DESIGN REVIEW COMMITTEE

August 19, 2026 6:00 PM

4.I. 3042 Lake Avenue Addition

DATE: August 13, 2026
TO: Tonya Hutson
FROM: Lynn Patterson
RE: **Design Review – 3042 Lake Avenue – Addition August 19, 2026**

2 SITE REFERENCE PLAN
SCALE: 1/16" = 1'-0"

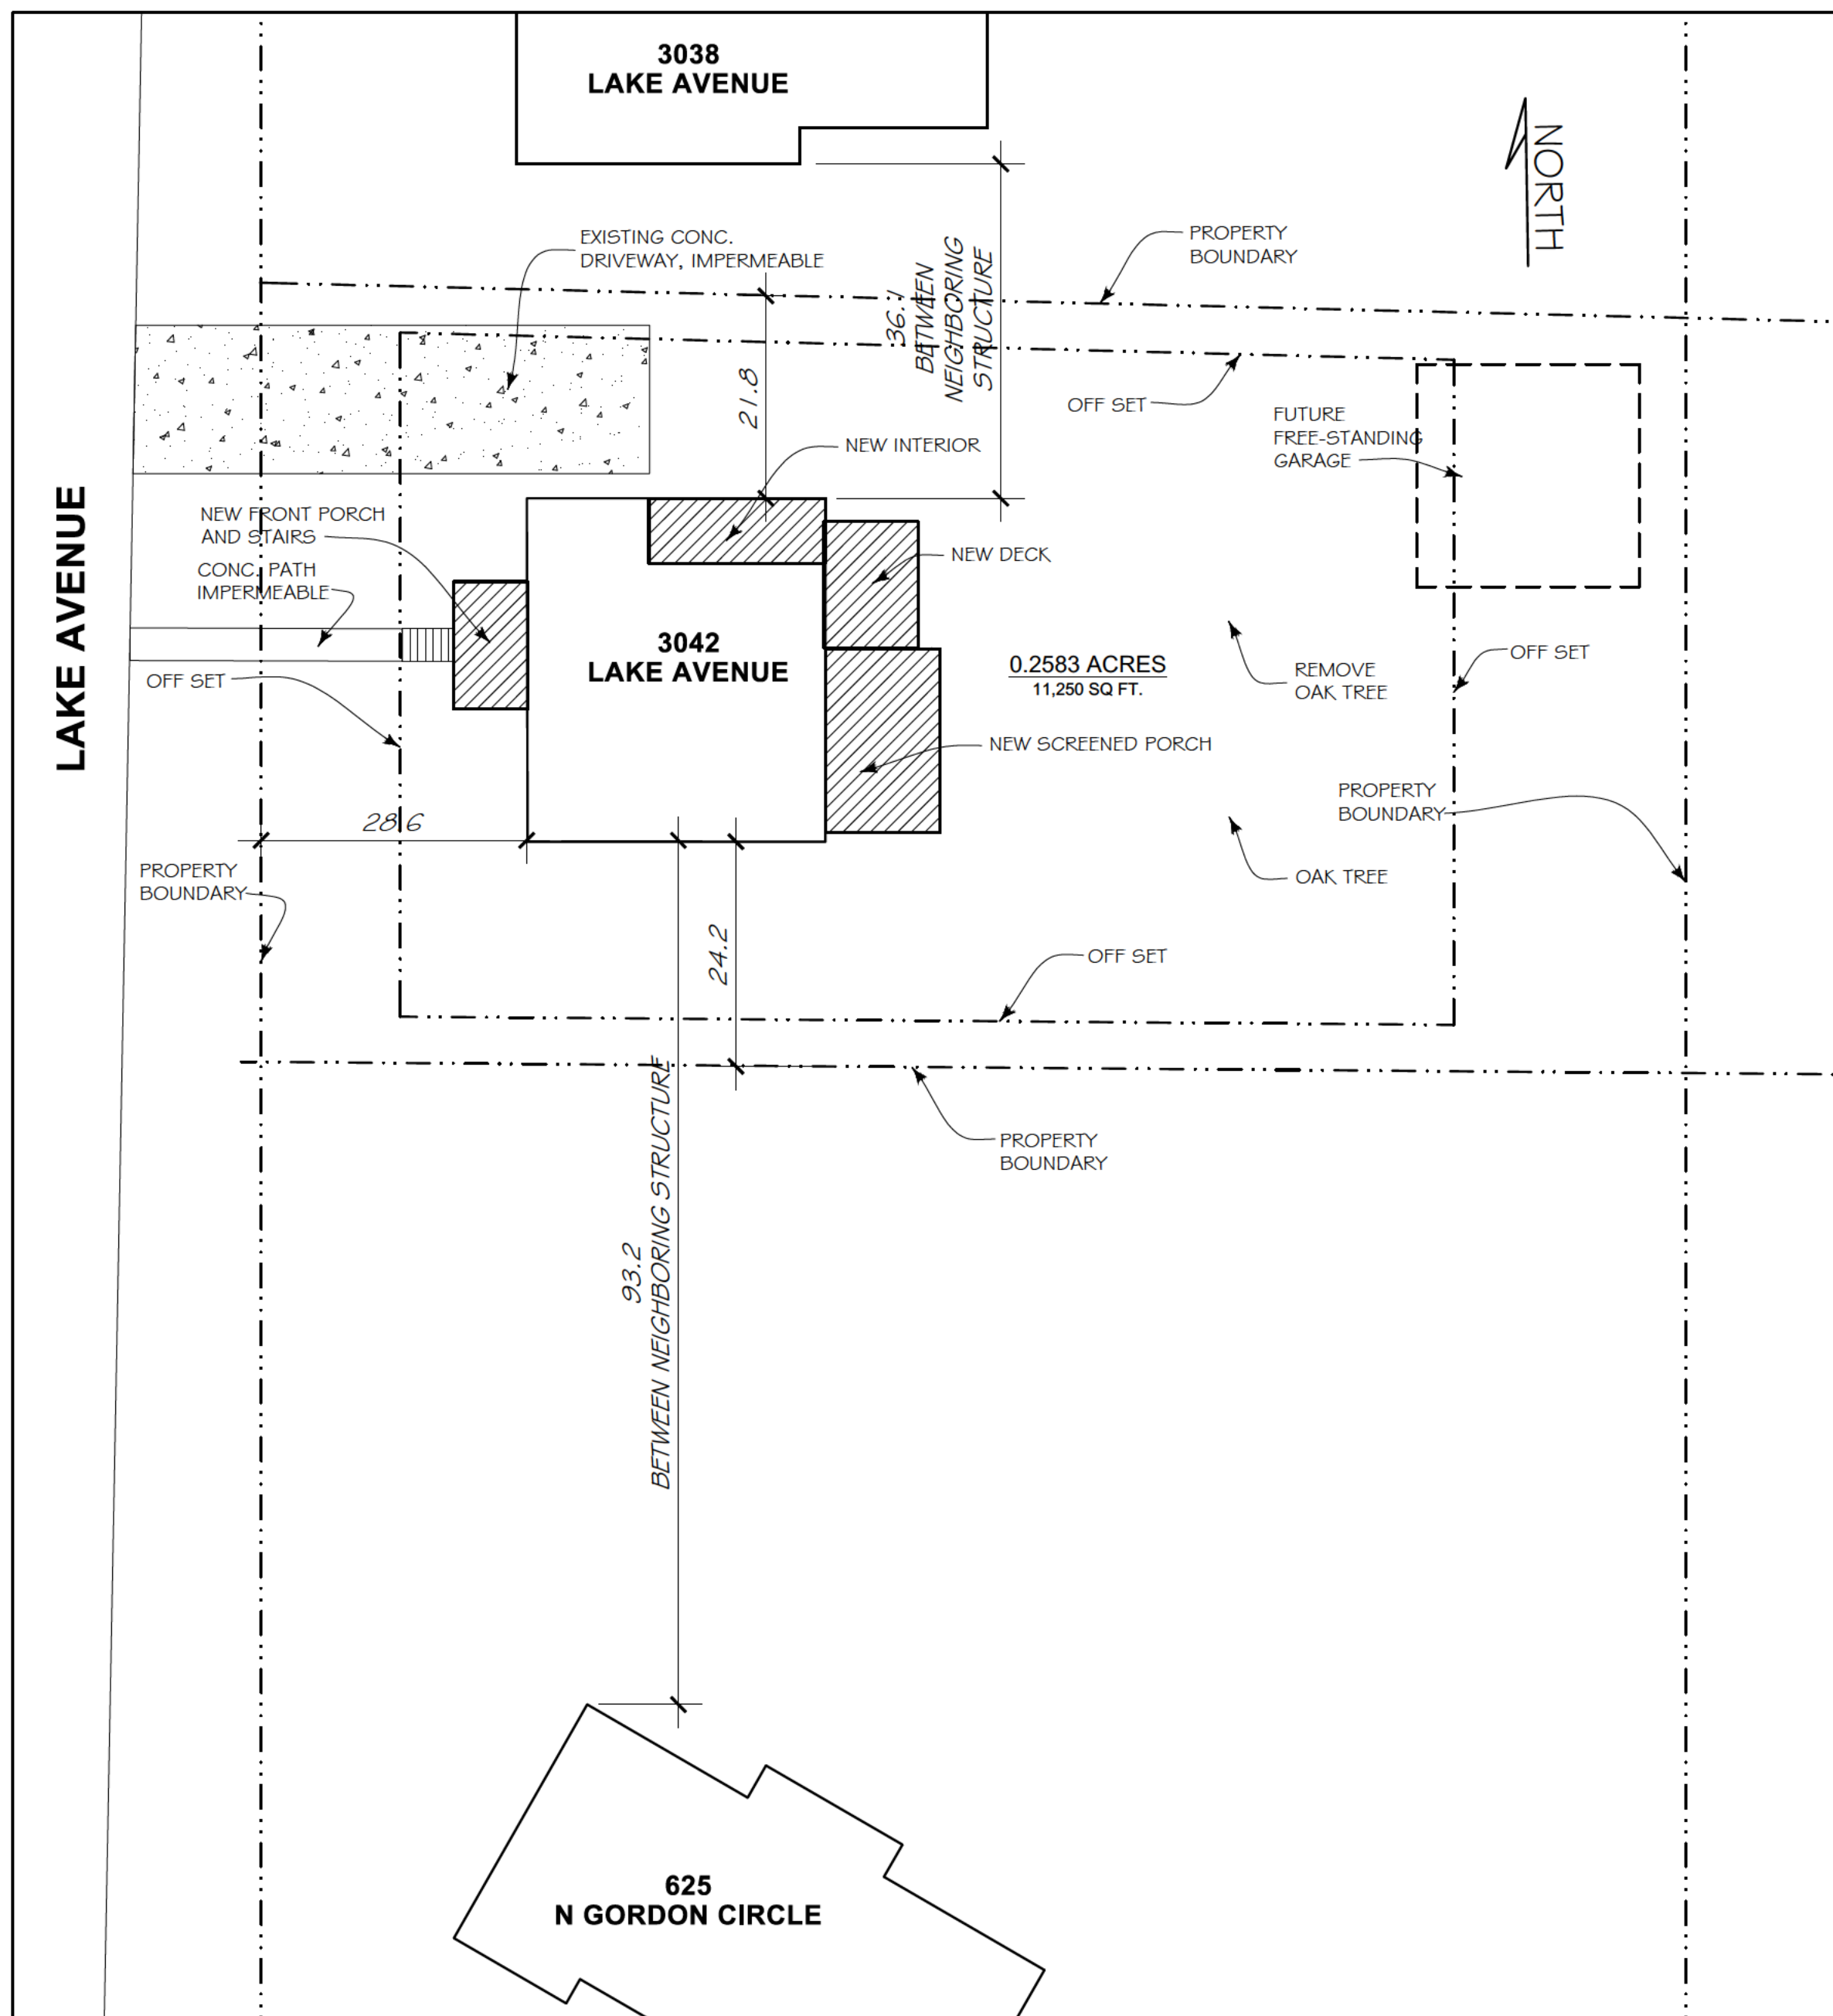
A future detached garage is shown on the site plan. Should a garage be proposed, it must be submitted to the City for appropriate reviews and approvals.

STAFF COMMENT: No landscape plan was provided for the addition. There appears to be a tree in the front yard. Please confirm.

1 FRONT - WEST
SCALE: 1/4" = 1'-0"

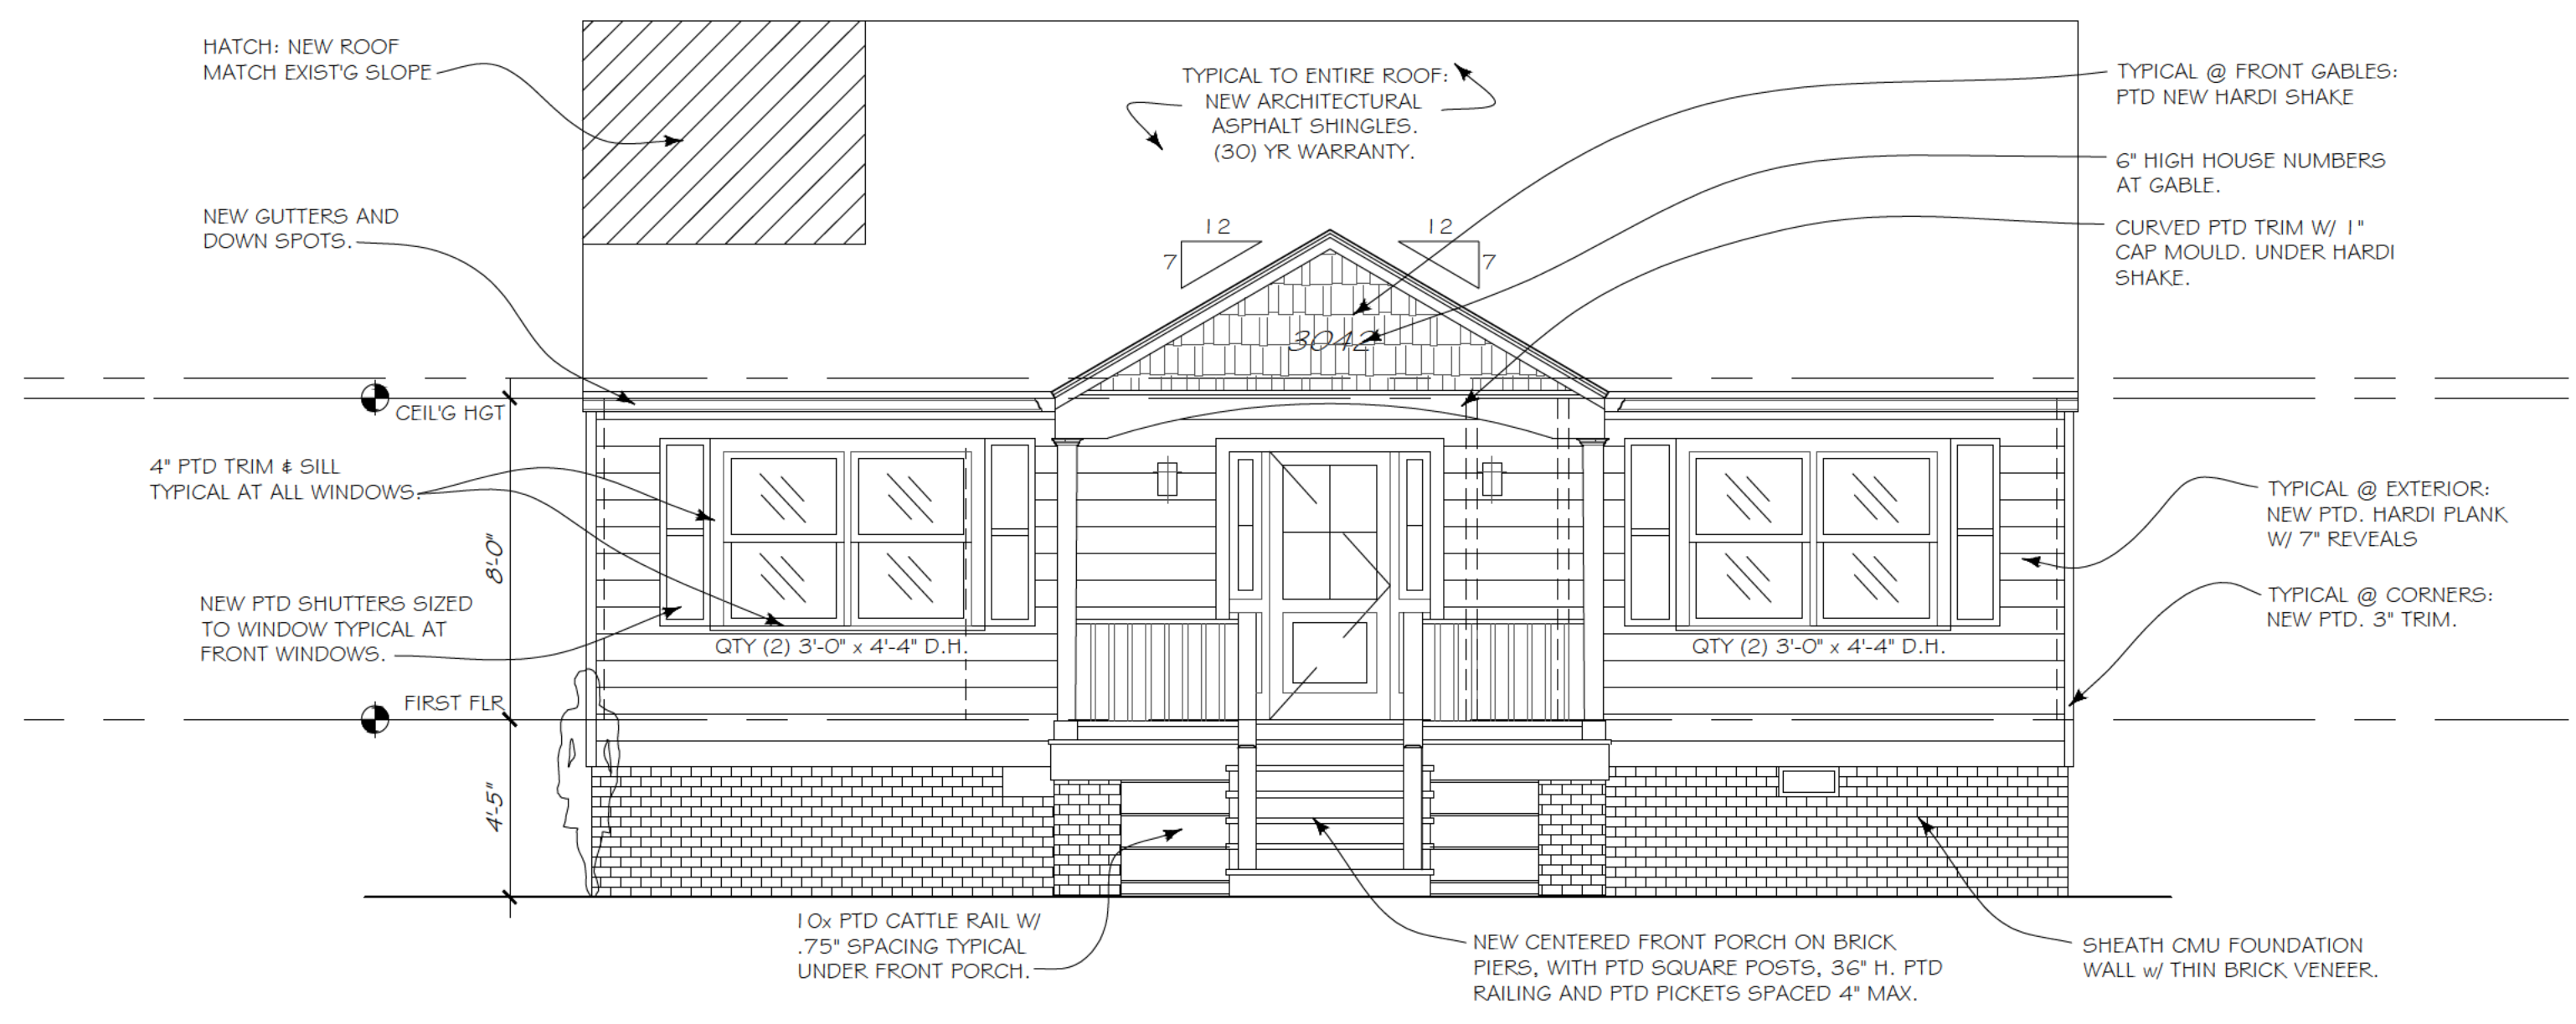
STAFF COMMENT: Front porch does not meet the 80% to 100% width requirement. Design Exception recommended
